SUBJECT: U.S. NUCLEAR REGULATORY COMMISSION JUNE 3, 2009, ONSITE
OBSERVATION REPORT FOR THE SAVANNAH RIVER SITE SALTSTONE
FACILITY

U.S. NUCLEAR REGULATORY COMMISSION JUNE 3, 2009, ONSITE OBSERVATION
REPORT FOR THE SAVANNAH RIVER SITE SALTSTONE FACILITY

Figure 1: ACI 117-06 Requirements

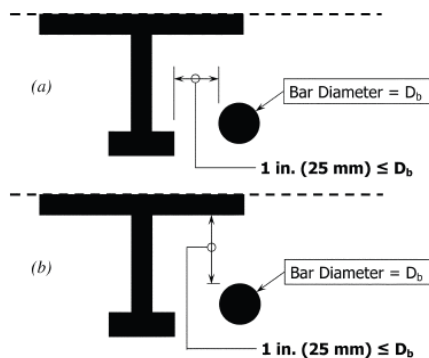
ACI 117-06, Section 2.3.1 (ACI, 2006) provides requirements for placement of embedded items and states “Clear distance to nearest reinforcement shall be the greater of the bar diameter or 1 in.” The commentary section R2.3 provides further clarification on this requirement with diagrams showing the clear distance should be from the embedment and the stud (Figure 1 shows the requirements designated by ACI 117-06 and Figure 2 shows a photograph of the closure strips used in disposal cell 2A [taken onsite during June 3 observation]).

Figure 2: June 3, 2009 Photograph of Closure Strip

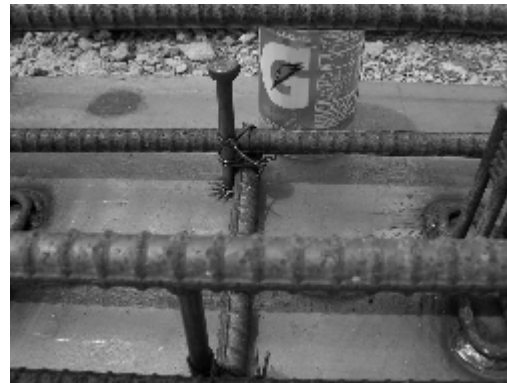
One of the intents of this requirement is to ensure proper concrete consolidation and bonding to all surfaces of the embedment and rebar and to prevent localized voiding issues. The steel closure strips were constructed with studs embedded in the concrete and rebar was placed less than 1” from these studs and in several instances actually in contact with the studs. Voiding issues of this sort could lead to preferential pathways within the disposal cell and could produce unforeseen weaknesses during the performance period. Given the potential for localized voiding created by this deviation, the staff recommends that DOE either confirm the absence of such voids or consider the potential for such voids in evaluating the performance of the cells.

DOE should either confirm the absence of voids caused by deviation from ACI 117-06, or consider the potential for such voids in evaluating the performance of the cells
